CRAN_NVL08228F_R03

USID #: 209934
PICO SMALL CELLADJACENT TO
12126 ALTA DRIVE
LAS VEGAS, NV 89135

AS-BUILT RECORD	
THE MARKS ON THIS DRAWING REFLECT THE AS-BUILT INSTALLATION.	
Subcontractor	Date
Wecom Inc.	12/31/19
Field Coordinator	Date
Marked Location	Date
Patricia Fleming	12/31/19

ENLARGED SITE PLAN

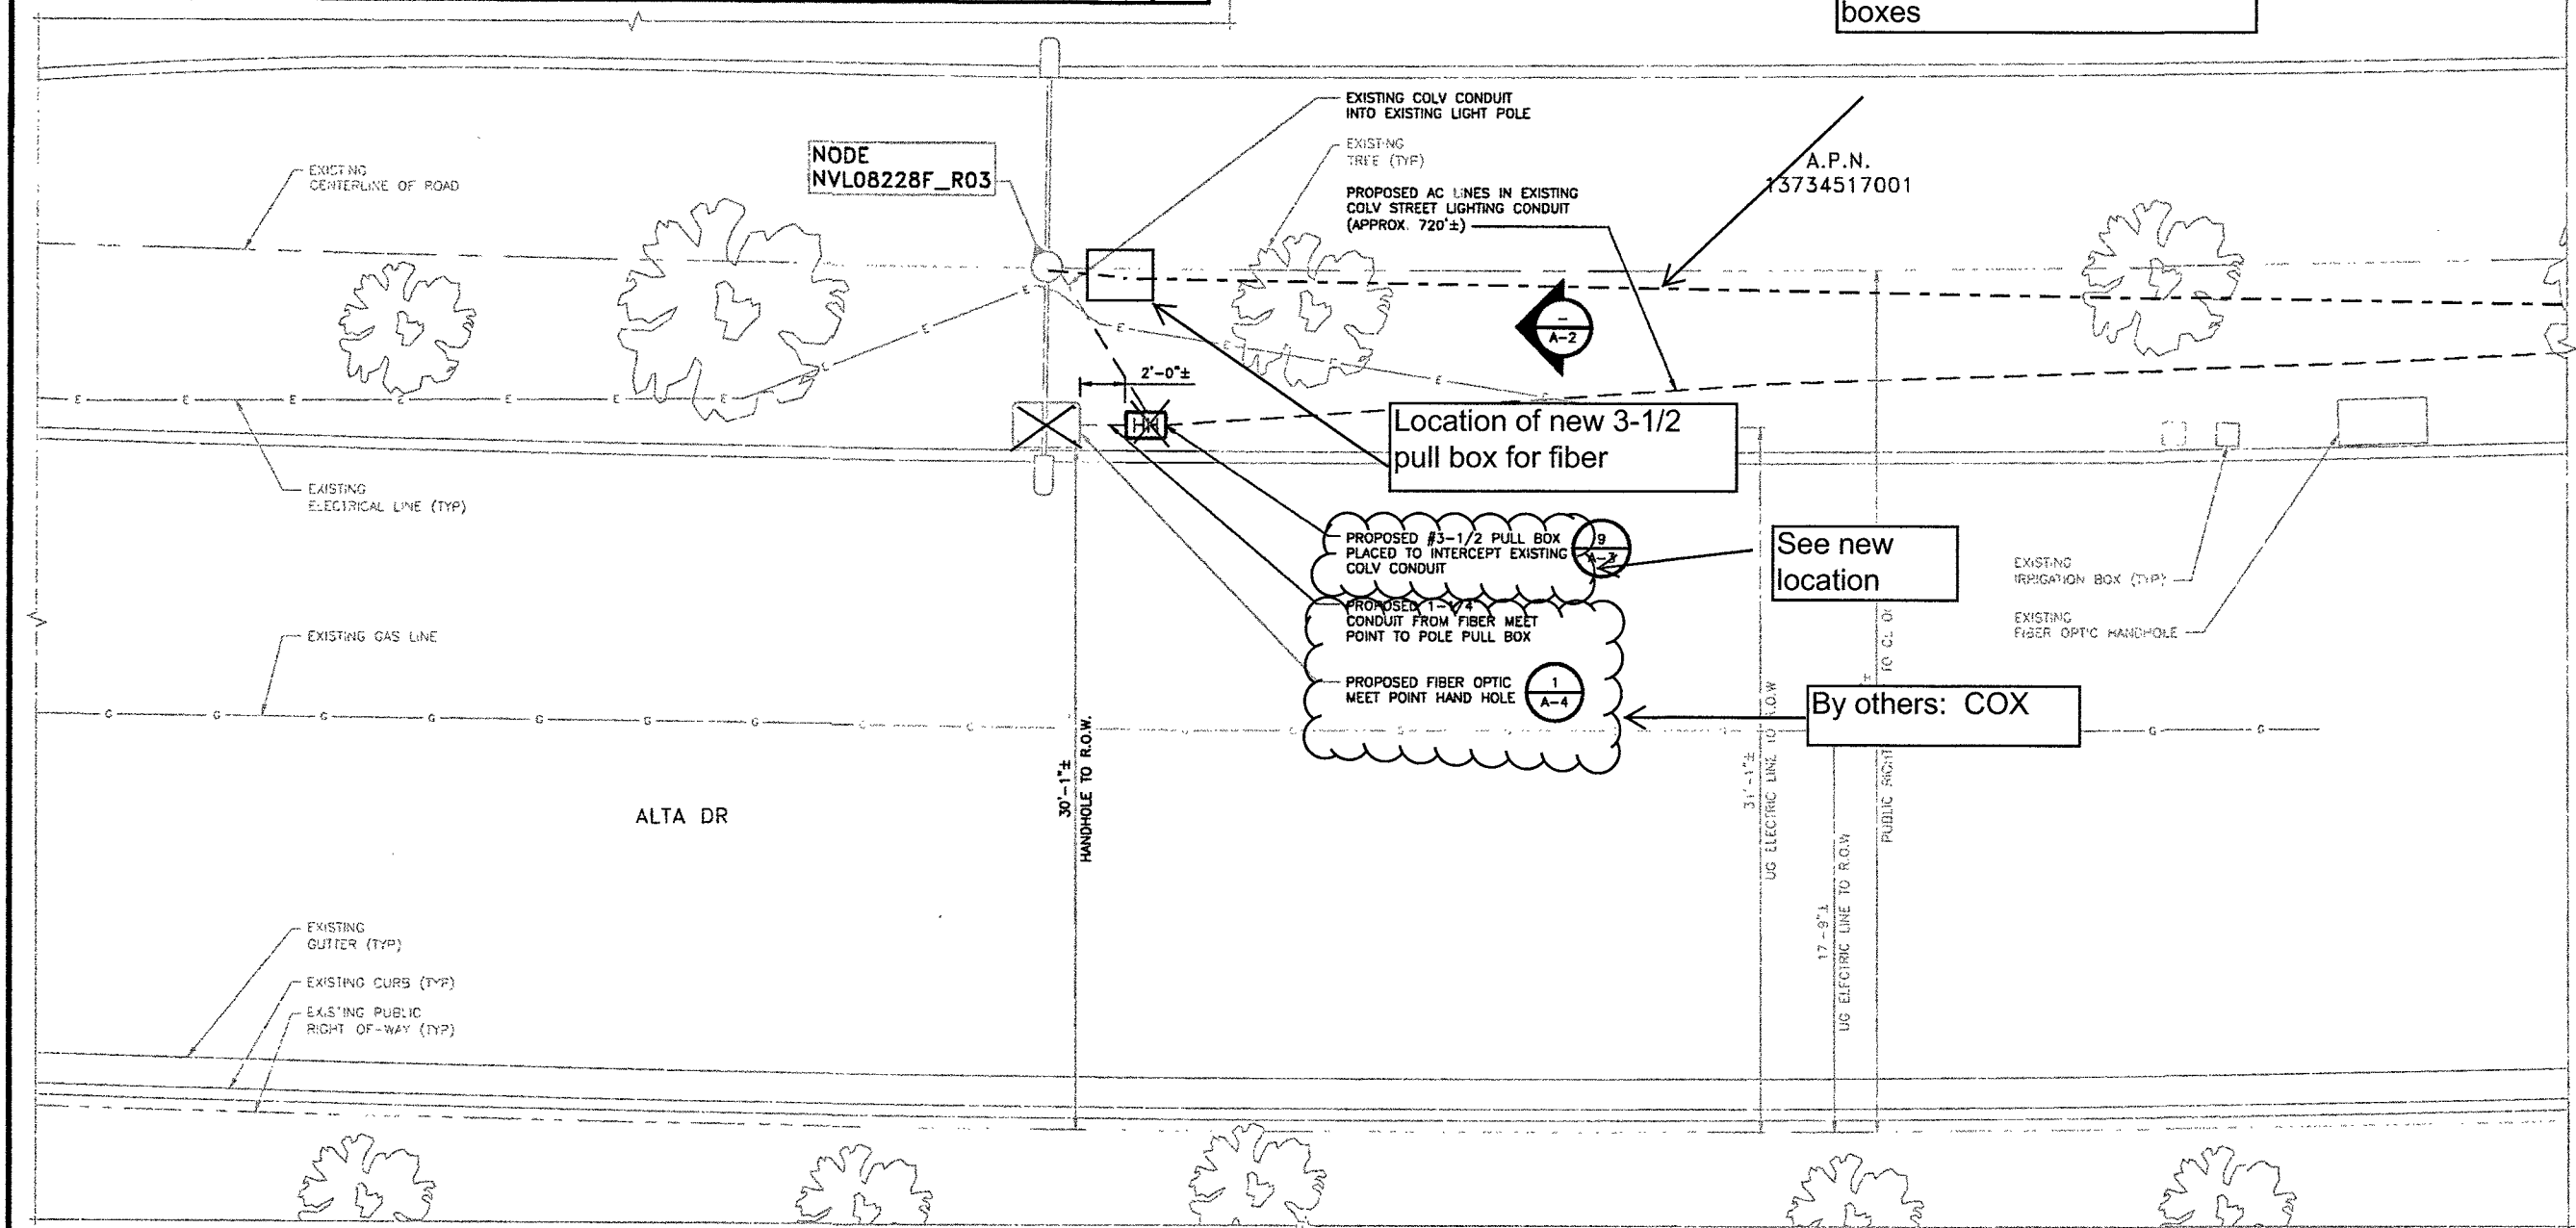
New 120V power circuit for small cell loops through existing light poles and pull boxes
